09 - 2011
BVR450 / BVR450Z / BVR450F
18V CONCRETE VIBRATOR (4.0FT)

SERVICE CHANGES

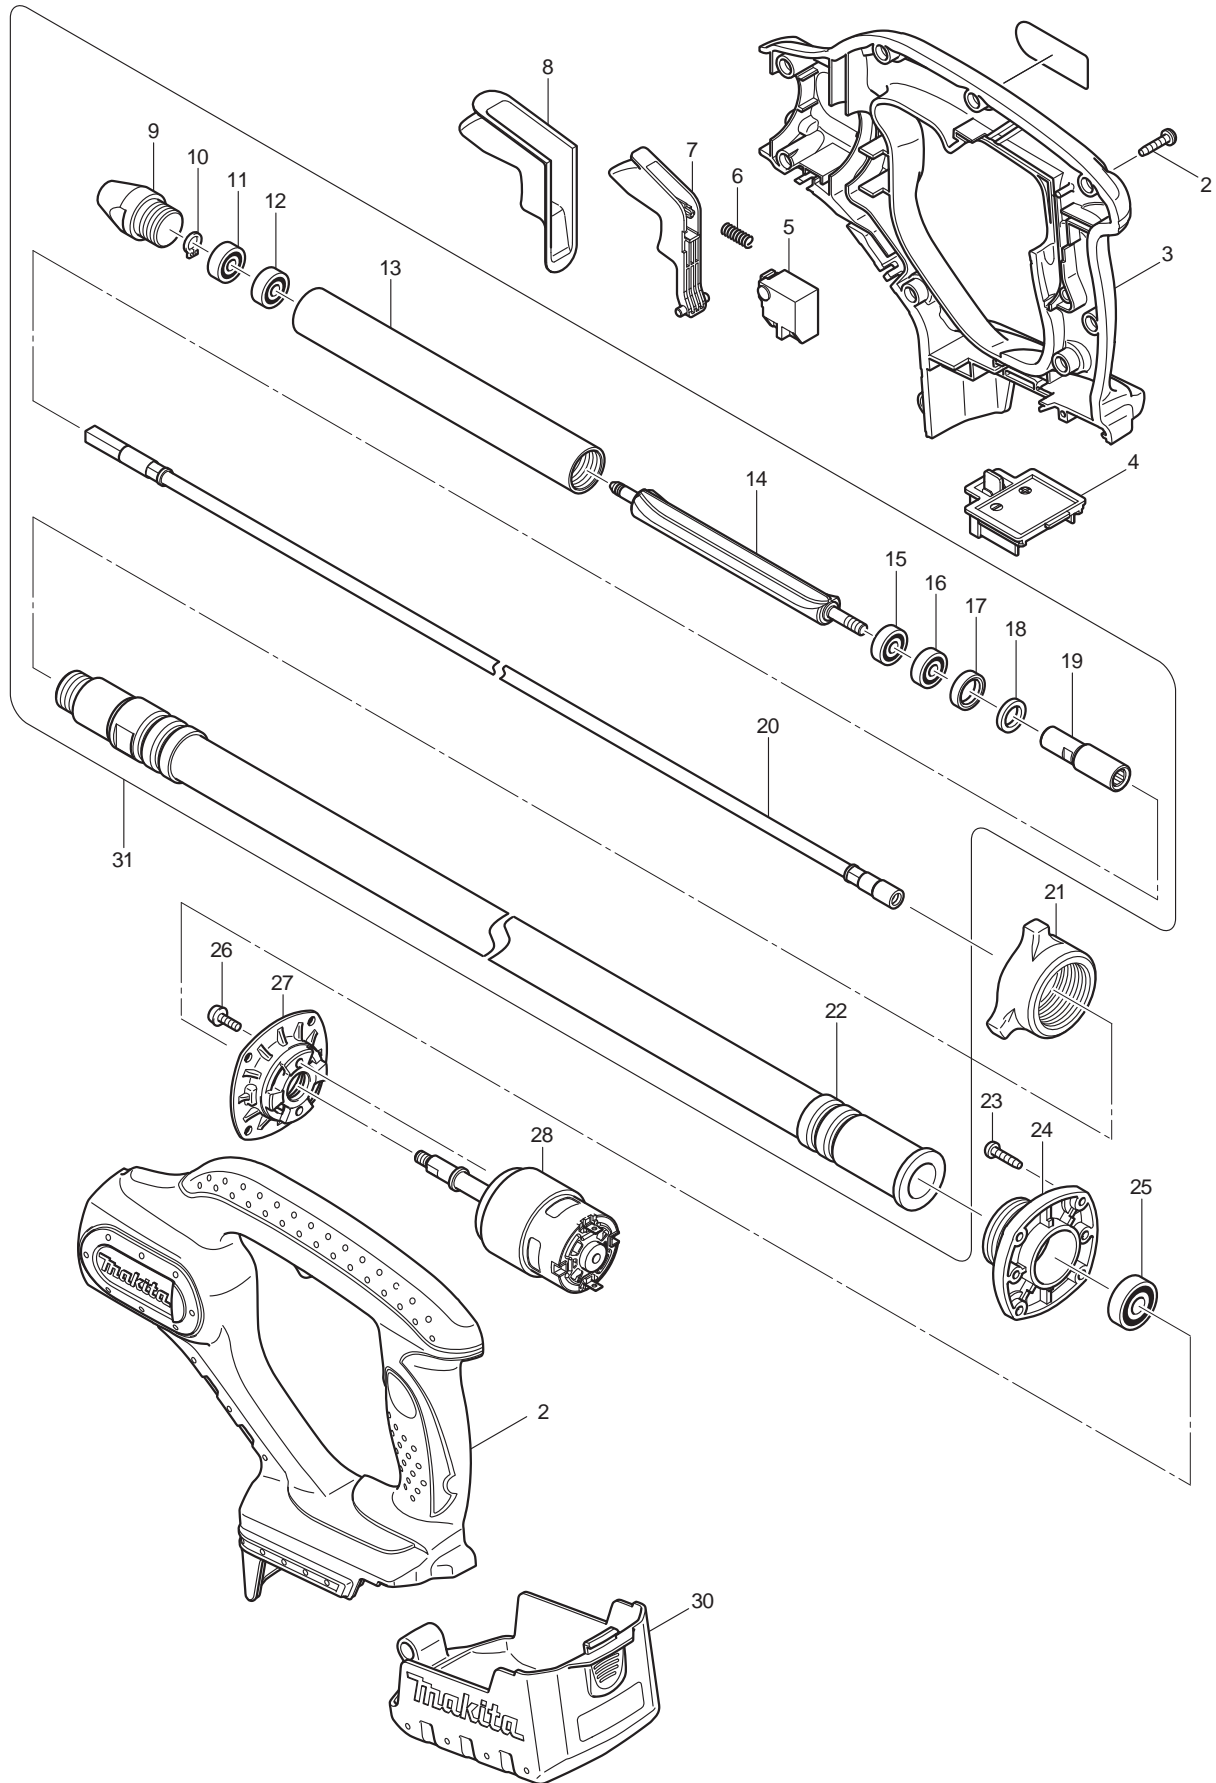
1. Changes on Flexible hose, wire, joint

Item No.	Description	Type 1	Type 2	
22	Flexible hose	163419-5	163537-9	(TI# 94292)
20	Flexible wire	163420-0	163534-5	(TI# 94292)
19	Joint	322969-1	326203-1	(TI# 94292)
Above parts are completely interchangeable as a set.				
31	Flexible Hose Assy	192954-6	126206-3	(TI# Y06773)
